DEPARTMENT OF PLANNING

SUBJECT: BILAMBIL VILLAGE RESIDENTIAL SUBDIVISION 08_0034 MOD 1

To determine a modification request for the Bilambil Village Residential Subdivision.

FIGURE 2: Close up view of the north-west part of the site subject to modification request. Approved subdivision layout in the north-west corner is shown on the right hand side (RHS). Site topography and aerial photograph is shown on left hand side (LHS).

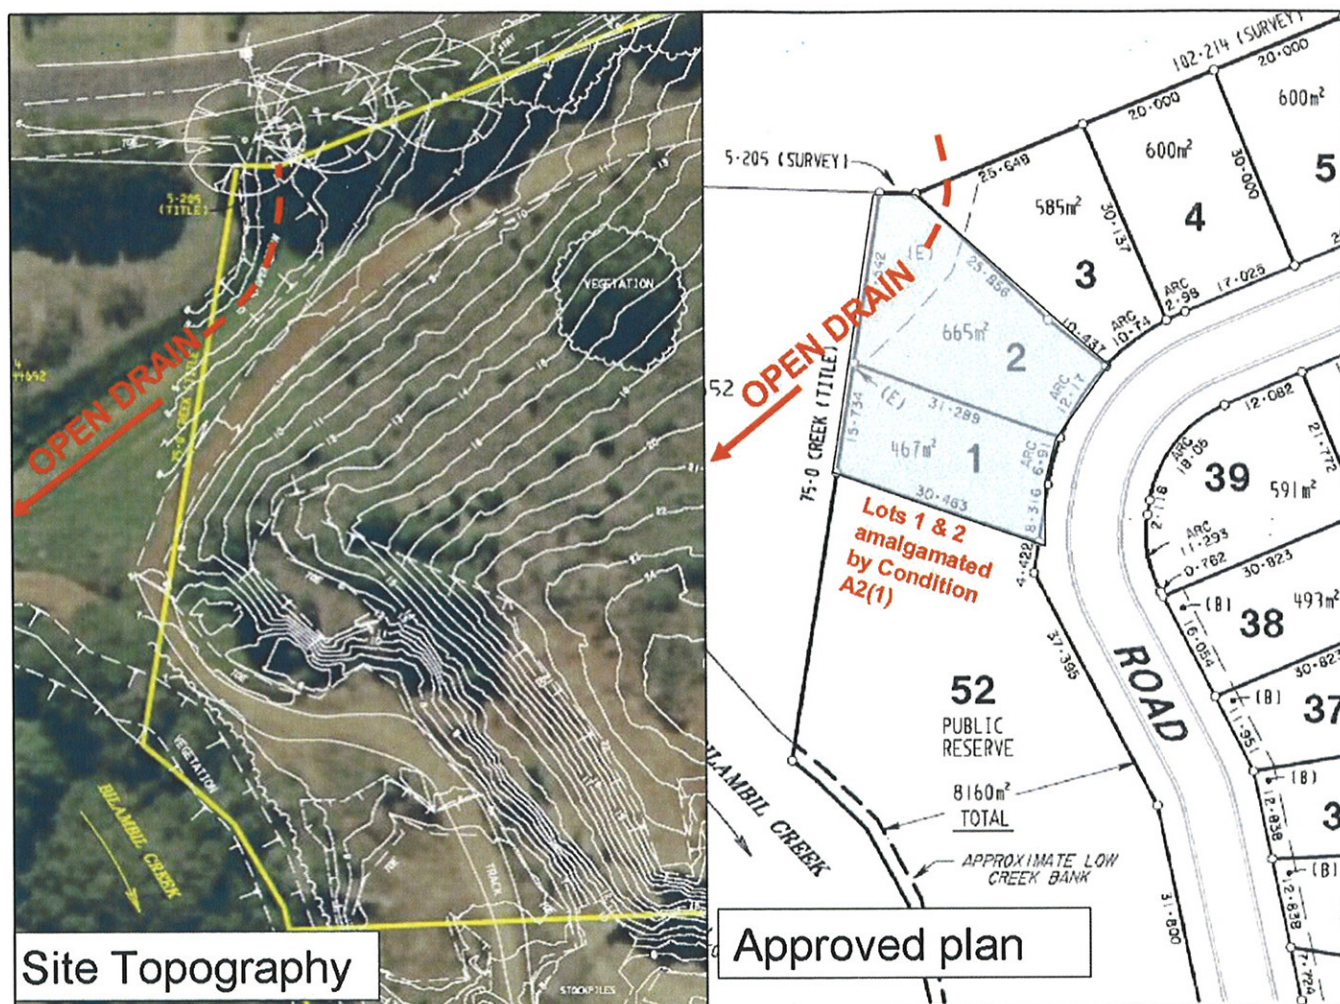
1. The proponent now seeks to delete condition A2(1) that currently requires the incorporation of Lots 1 and 2 to form a larger lot and regain Lot 1.
2. In addition to this modification, the proponent also seeks to fill the existing open drain at the rear of Lots 1, 2 and 3 and replace it with a pipe and culvert.

The RFS advised that any future dwelling on proposed Lot 1 would require a minimum 15m Asset Protection Zone (APZ) to the south, from any unmanaged vegetation within the adjoining public reserve. This assessment was based on classification of the vegetation adjoining as rainforest and an effective downslope of 5-10 degrees.

Council raised concern regarding the adequacy of the APZ and its impact on the riparian zone and environmental buffer width to Bilambil Creek. Council also reiterated its opposition to proposed Lot 51 (the neighbourhood park) and its inadequacy in terms of configuration and shape. Amended section 94 contributions (of the *Environmental Planning and Assessment Act 1979*) and section 64 contributions (of the *Local Government Act 1993*) were also provided, but these were not considered relevant to the

Therefore for the reasons detailed above, the Department is not able to support the proponent's modification request to reinstate Lot 1. Furthermore, conditions will be amended to ensure a 15m wide APZ is provided for on the Lot created by the amalgamation of Lots 1 and 2.

FIGURE 4 Plan showing buffer width in relation to Creek boundary dated 14 September 2010. This plan shows the 35m riparian buffer along the extent of Lot 52 in relation to low creek bank, high creek bank and the Creek centre line (legal boundary)

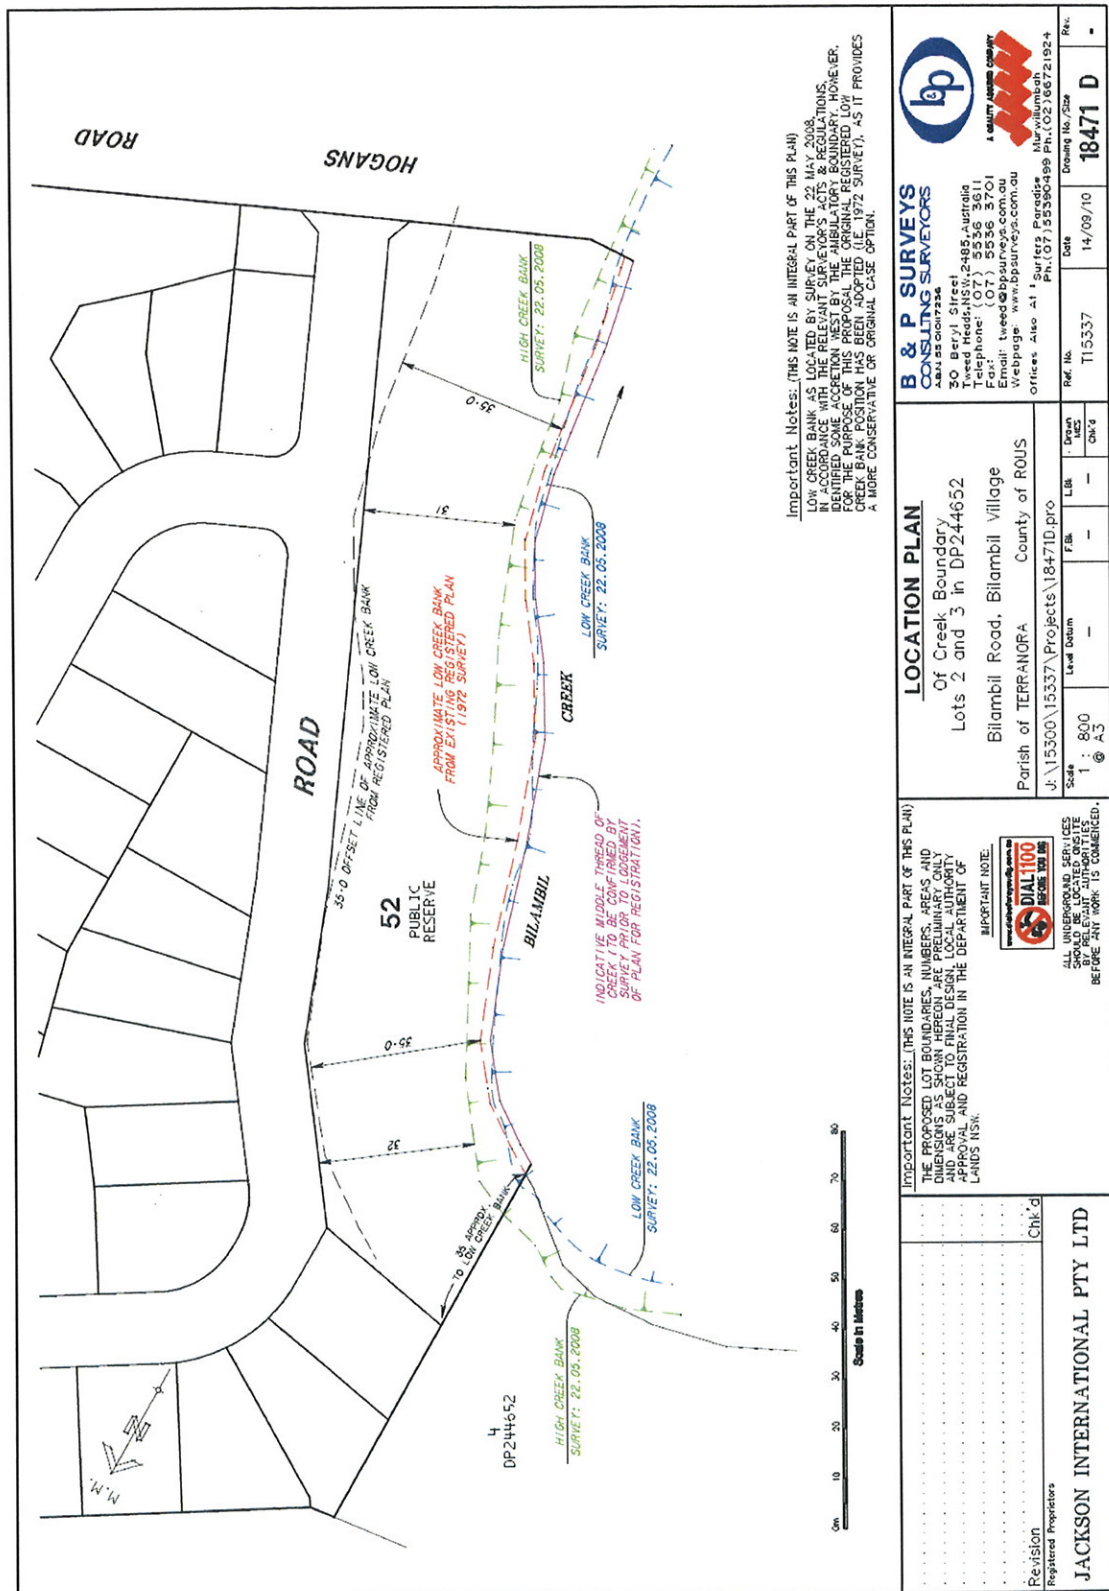
The proponent has also submitted an additional plan depicting the variously surveyed margins of Bilambil Creek (refer Figure 4 above). This plan shows the Creek banks as they were surveyed in May 2008 against an inferred position of low creek bank and the middle thread from the original survey in 1972. A previous submission from the Land and Property Management Authority (18 August 2009) advised that the proponent had title to the middle thread of the Creek (*ad medium filae aquae*). Final property boundaries, dimensions and present location of both low and high Creek banks are likely to be confirmed in application for the subdivision certificate.

The proponent contends that the 1972 survey used low creek bank for the legal boundary rather than the middle thread of the Creek. The proponent then goes on to argue that a 35m wide environmental (riparian) buffer can be achieved using the low Creek bank as defined in 1972. The survey completed of the site in 2008 confirms that low creek bank in this location is further eastward – confirmation that ‘real’ riparian width in this vicinity is already reduced. It is also worth noting that effective buffer width is normally calculated excluding the steep area between the low and high Creek banks.

Notwithstanding, the Creek bank in the vicinity of Lot 1 is situated on the outside of a bend in the Creek and therefore is subject to stronger, persistent erosive forces. It could be expected that further erosion is likely to occur on this corner and further reduce the actual environmental (riparian) buffer in this area.

Although variable, in general the nominal 35m buffer to Bilambil Creek is achieved along the entire margin of Lot 52 with the approved plan of subdivision. The variability arises from natural erosion and accretion cycles of the banks of Bilambil Creek. As Table 1 shows, the nominal 35m buffer is already reduced in the vicinity of Lot 1.

Although detailed survey plans are required to be approved prior to the issue of a subdivision certificate for the development, the precautionary principle must be applied and the originally approved condition A2(1) retained. Therefore any further reduction in environmental (riparian) buffer width in this vicinity is not supported.
